**Subject:** Inspection or modification of elevator and elevator trim control system

**Concerned:** G 115/ G 115A/ G 115B, all S/N's

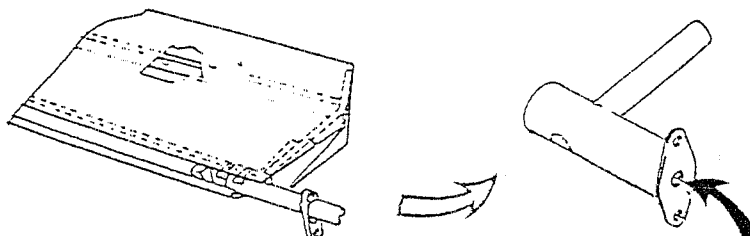
**Actions:** A. All parts of the elevator trim control system in the horizontal tail area must be inspected visually for corrosion.

Corroded parts must be exchanged (refer to sketch).

**Note:** The stud bolt plate (21), covered with laminate, must not be exchanged necessarily. It is permissible to remove corrosion from stud bolts and protect stud bolts with corrosion protective (e.g. LPS 3).

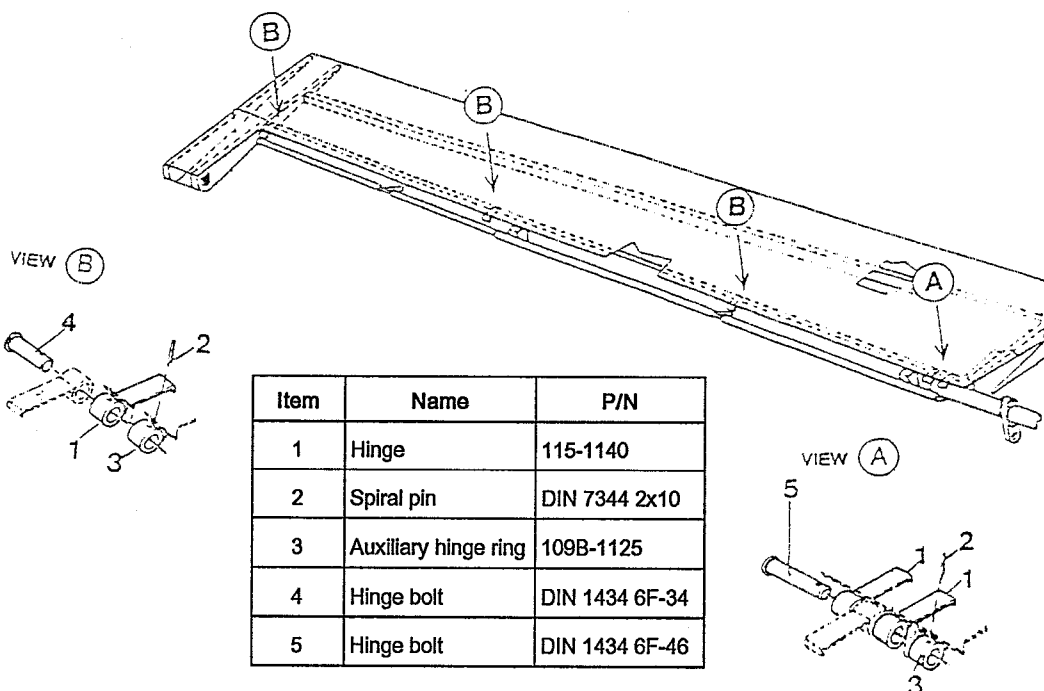
- B. The inspection or the exchange of the elevator mounting (lever L/H P/N 115-3573 and lever R/H P/N 115-3572) must be performed as follows:
1. Remove rudder, according to MM Chapter 27-20-30
  2. Remove elevator, according to MM Chapter 27-30
  3. Check L/H and R/H lever through the hole for internal corrosion (refer to sketch)

4. If corrosion is detected, the elevator mounting (lever L/H P/N 115-3573 and lever R/H P/N 115-3572) must be exchanged.

For exchange, the elevator must be sent to the manufacturer.

**Note:** If the extent of corrosion can not be determined exactly, the elevator may be sent to the manufacturer for inspection.

5. If the corrosion is only surface corrosion (very thick film of rust), the corrosion must be removed as far as possible and the lever protected internally using a proper corrosion protective (e.g. LPS 3), to restrict further corrosion.

**C. Check trim rod 3 for corrosion.**

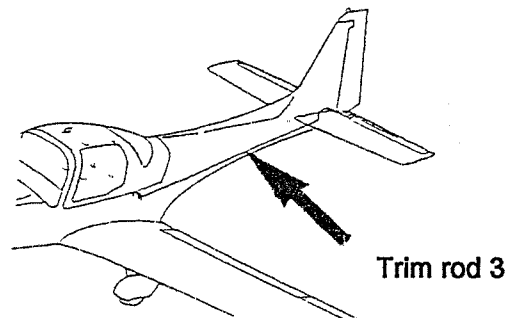
**Note:** The installation of an auxiliary hinge ring is recommended for an easier assembly (refer to IM 115-19). A 6 mm longer hinge bolt must be used! (refer to sketch)

If corrosion is detected, trim rod 3 must be exchanged according to MM Chapter 27-40.
